RECORD OF DECISION ASPEN SQUARE MANAGEMENT GARAGE MASTER PLAN December 18, 2001

The Applicant seeks to add garages to existing houses on lots 2-34; 37-46 as shown on plans entitled "Conceptual Plans for Residential Garages" sheets 1 and 2 prepared by Howe Surveying.

Site plan approval (on a conceptual level) for 53 garages and a Certificate of Appropriateness for new construction in the Devens Historic District.

<u>X</u>-1

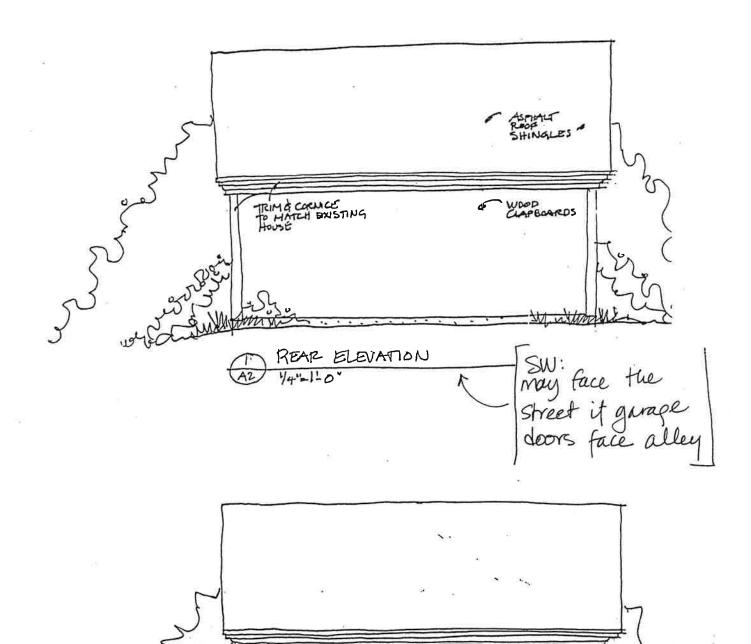
Garages constructed through a Level I permitting process must utilize approved historic designs submitted as part of the package (sketches A-1, A-2, and A-3). Garages may be resized smaller, but retaining same detailing and proportions and not require a Level II review (but require the submission of detailed building permit plans). Any increase in size beyond the prototypes is Level II.

Stamped building submittal (foundation, cross-section, details, and elevations) plans for the detached two-car garage (sketch A-2) and the attached two-car garage (sketch A-1) for the colonials shall be prepared by Aspen and submitted to the Devens Building Inspector prior to the commencement of Level I garage permitting.

4) The wall of the detached garage facing a public way shall contain a window in the size and number of panes as shown on sketch A-2 and/or door. The door may be a four-panel, six-panel, board and batten, or multipaned window over two-panel (as shown on sketch A-1) door.

A-2

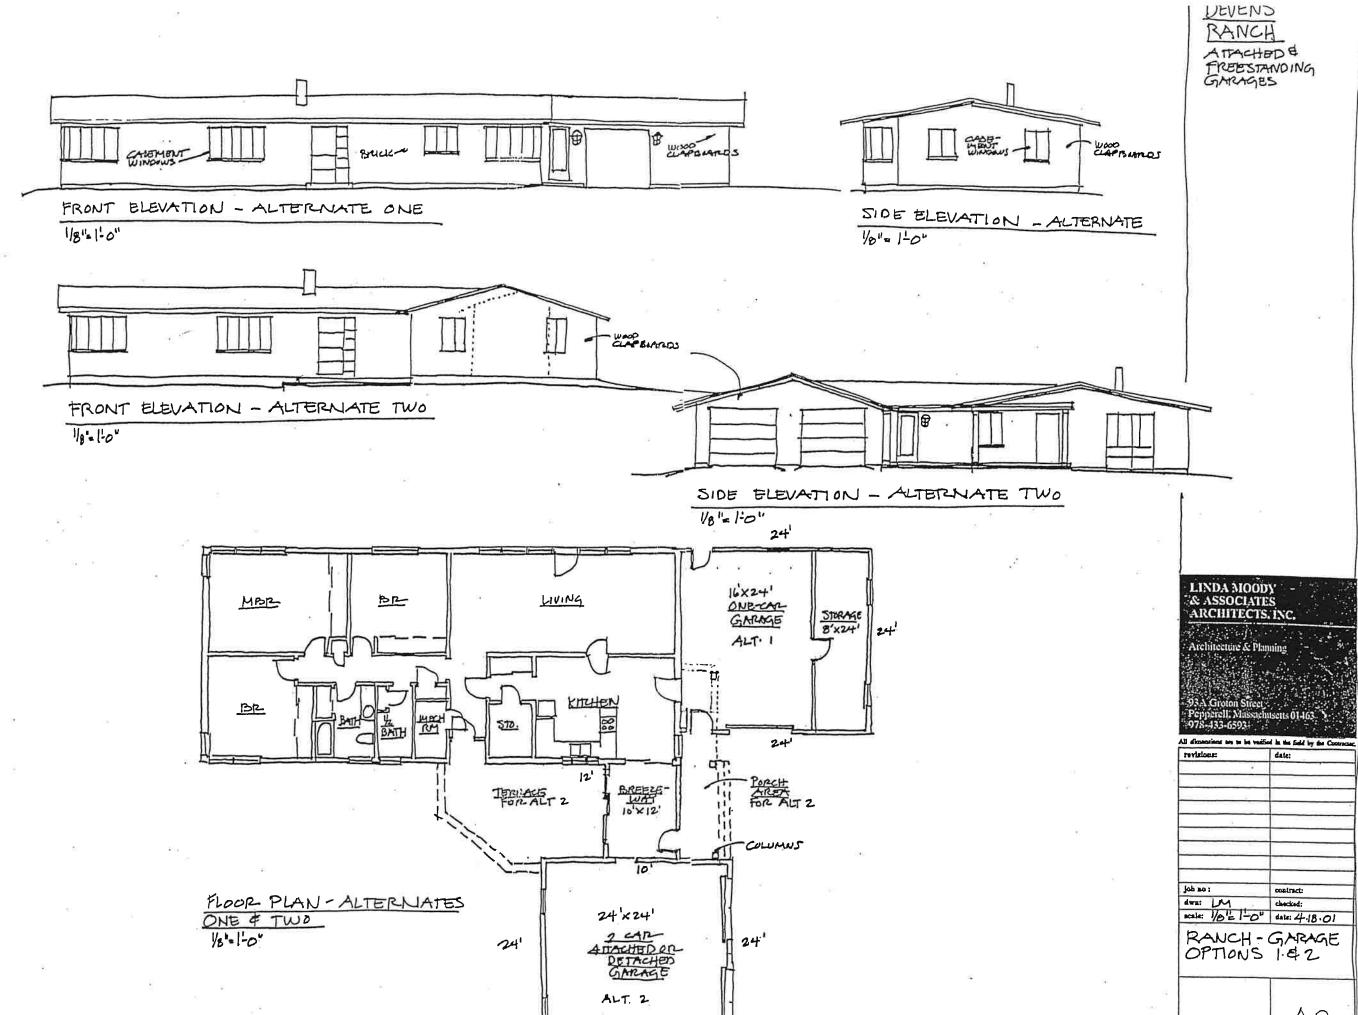
3) Detached garages shall be oriented such that the ridgeline of the garage is roughly parallel to the ridgeline of the adjacent house. [12-10-01]
